**16/01142/FUL (CT.5795/W)**

**Item No 03:-****Alterations and extension to dwelling at Elmleaze Farm Westonbirt Road  
Westonbirt Tetbury Gloucestershire GL8 8QE**

<b>Full Application 16/01142/FUL (CT.5795/W)</b>	
Applicant:	Mr & Mrs Fitzpatrick
Agent:	Andrew Miles
Case Officer:	Claire Baker
Ward Member(s):	Councillor Jim Parsons
Committee Date:	14th September 2016
<b>RECOMMENDATION:</b>	<b>REFUSE</b>

ELEVATIONS  
AS PROPOSED

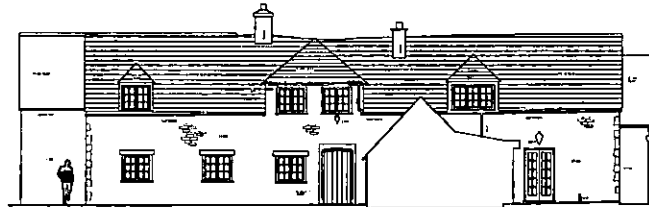
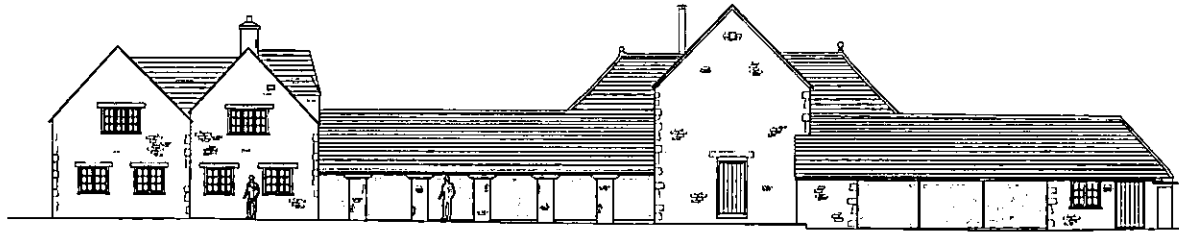
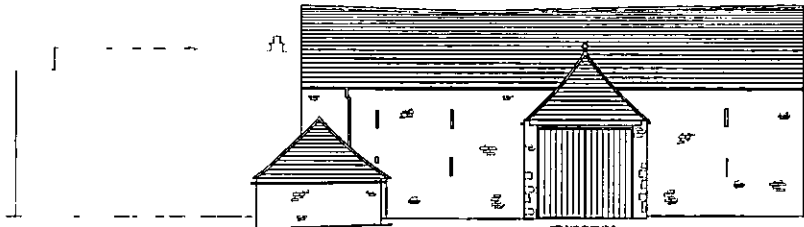
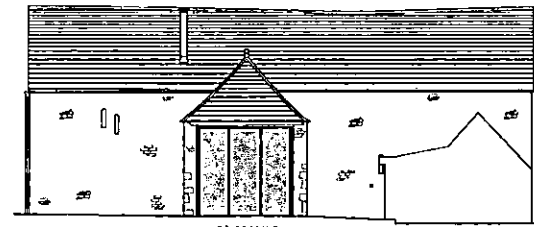
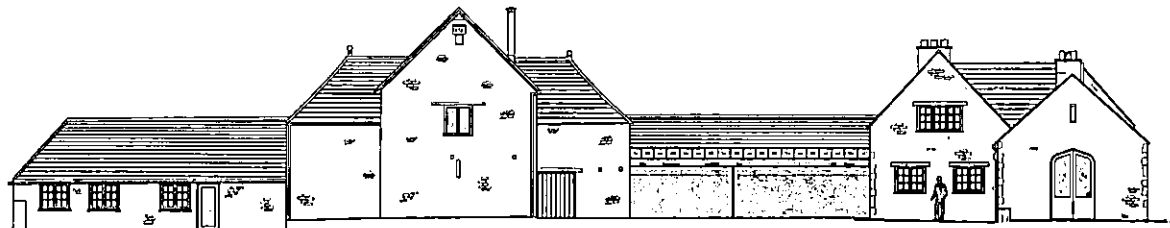
The historic appearance of west elevation of the listed barn and its interaction with the shelter shed would be wholly altered in character by the changes, including the structural glass wall, resulting in a negative visual impact upon the listed barn.

The proposal includes the introduction of a full height glazed screen to the south elevation of the Eastern shelter shed. Officers have no objections to the removal of the existing stable doors which are not of historic interest and there are no objections in this case to the introduction of full height glazing. However, it is considered that such a glazed screen would appear as an incongruous visual departure from the vernacular context of the barn and shelter sheds. This proposal would however appear more sympathetic if the form of the opening maintained a traditional visual rhythm through the introduction of vertical elements such as oak posts. Such design details could be agreed through a suitably worded planning condition if Members were minded to permit the application.

ELMLEAZE BARN HOUSE  
 WESTONBIRT  
 PROPOSED ALTERATIONS  
 GROUND FLOOR PLAN  
 AS PROPOSED

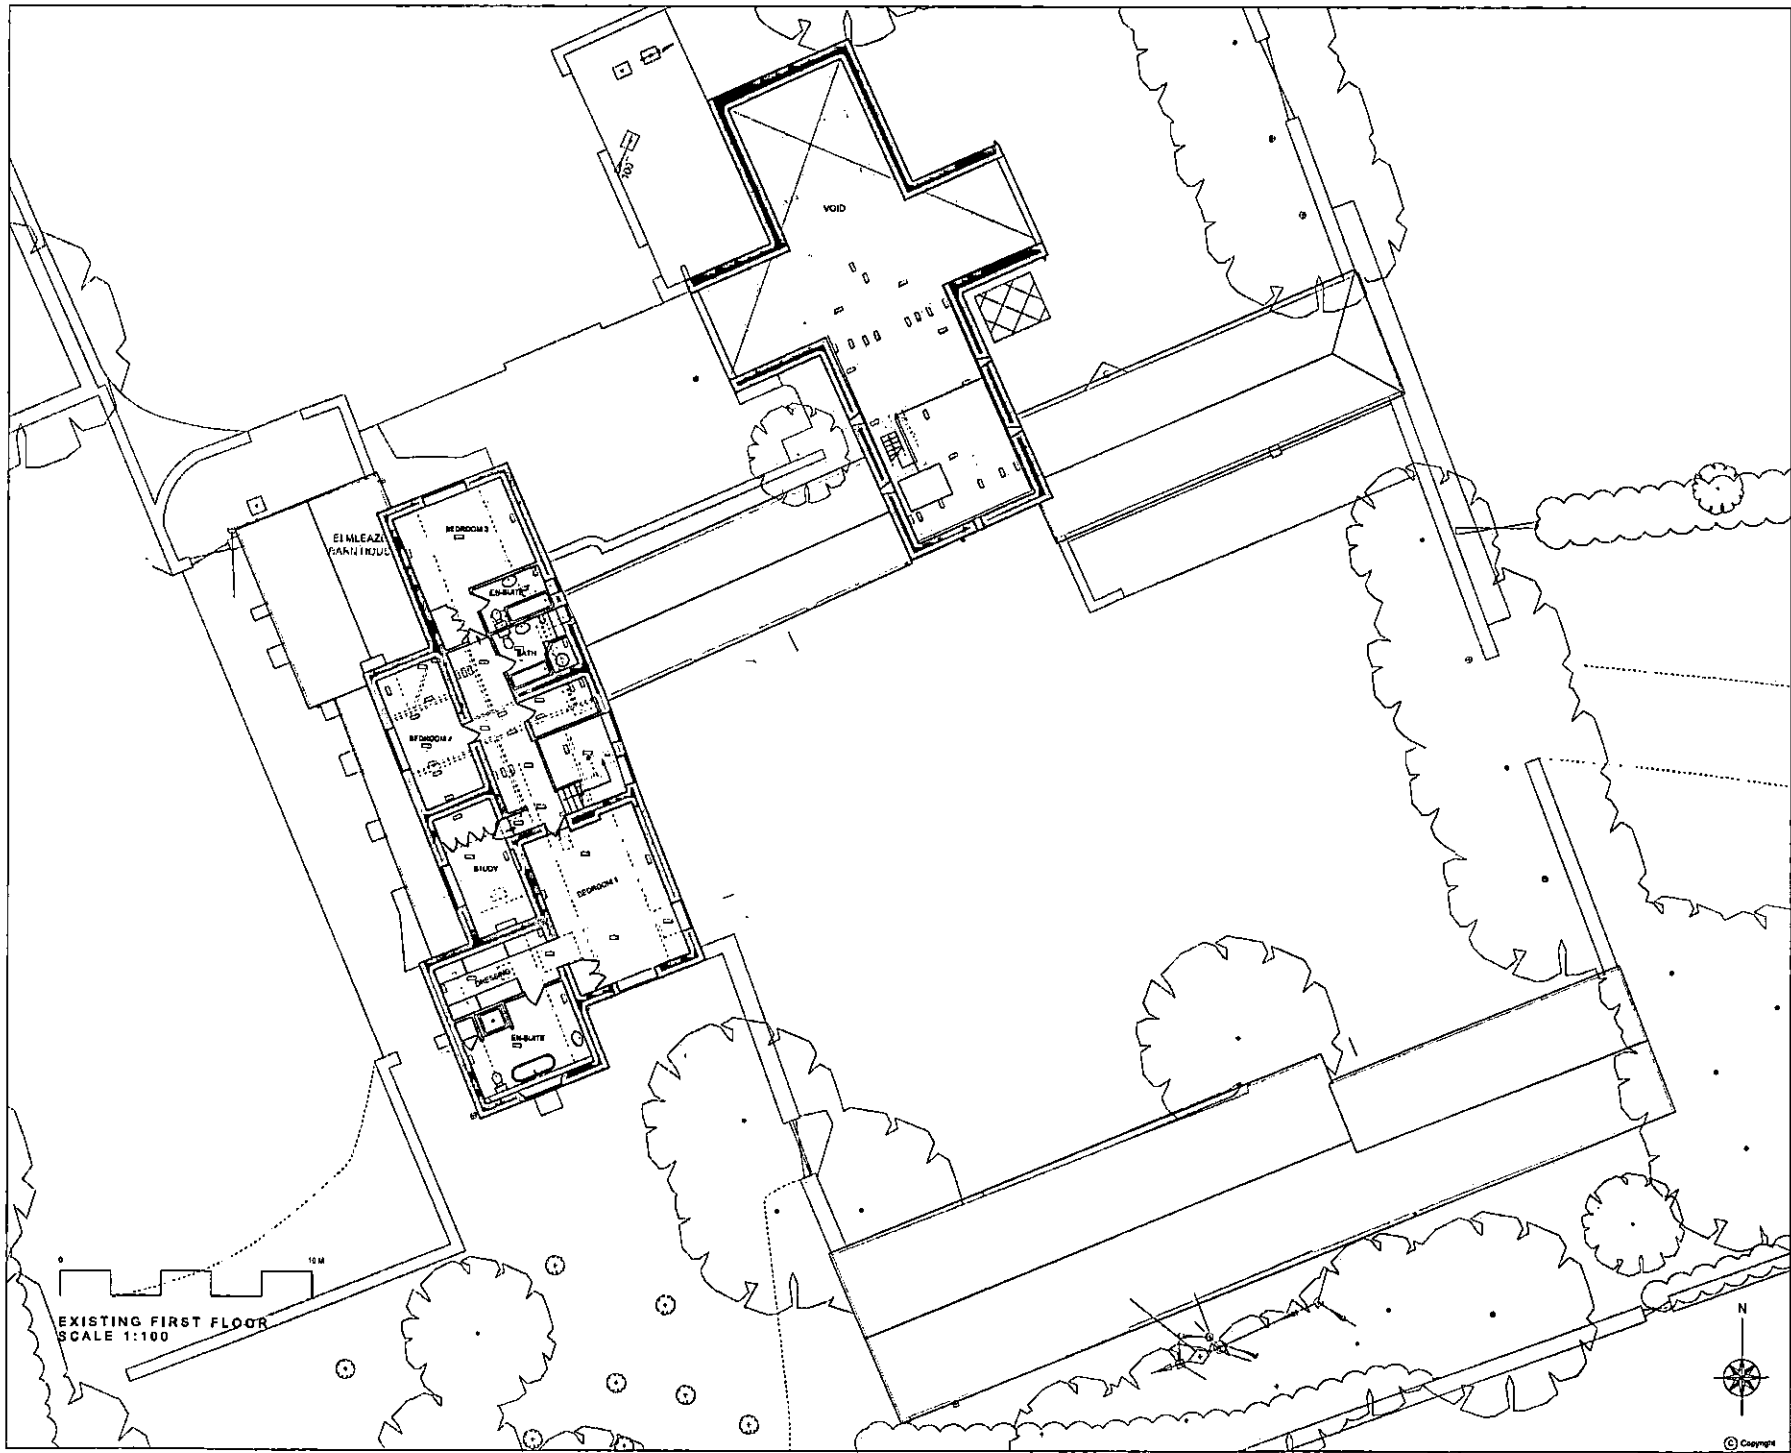
The proposal is to remove a substantial section of the North/rear wall of the shelter shed, construct a structural glazed wall approximately 1.5m to the North and bridge the gap with a shallow zinc covered lean-to roof. The building has been altered over time and some areas may have been repaired or rebuilt however the form and fabric of the historic building appears to remain substantially intact and legible as the original shelter shed. Historic buildings will inevitably be altered and added to over time but this does not necessarily diminish their overall significance. The wall proposed for removal represents historic fabric which forms a strong element of the significance of the building. Furthermore its location maintains the tangible dimensions of the

It would remove a substantial section of historic stone wall forming a fundamental component of the original shelter shed resulting in the loss of historic fabric.

The historic form and proportions of the original shelter shed would be obscured and rendered illegible by the moving of the wall out to a new position resulting in a dilution of the vernacular integrity of the original building form.

The proposal includes the opening up of new doorways at ground and first floor level to link through to the eastern shelter shed. In terms of the protection of the historic fabric of the building it is desirable to minimise new openings unless fully justified. Officers consider it to be logical that a doorway could be required to link the buildings at ground level however there appears to be little justification for a new doorway to access the mezzanine within the barn. The proposal is to access the mezzanine via a new spiral staircase within the eastern shelter shed which officers consider to be an unnecessary and invasive intervention to achieve what is already available. The mezzanine could simply be accessed via a staircase located within the barn, as it is now, without the need to alter the historic fabric. As such this proposal would result in an unnecessary loss of historic fabric which would be harmful to the significance of the heritage asset and is not outweighed by any public benefit.

This element of the proposal has been the subject of extensive pre-application advice during which Officers have consistently advised that the proposal would not be supported. Officers consider that some form of modest opening in the wall may be supported if the impact upon the appearance and physical fabric is limited and the wall remains substantially intact. Officers considered that there is sufficient scope within the footprint of the existing house to arrange accommodation which provides a view of the garden to the north if required without alteration of the wall of the shelter shed.
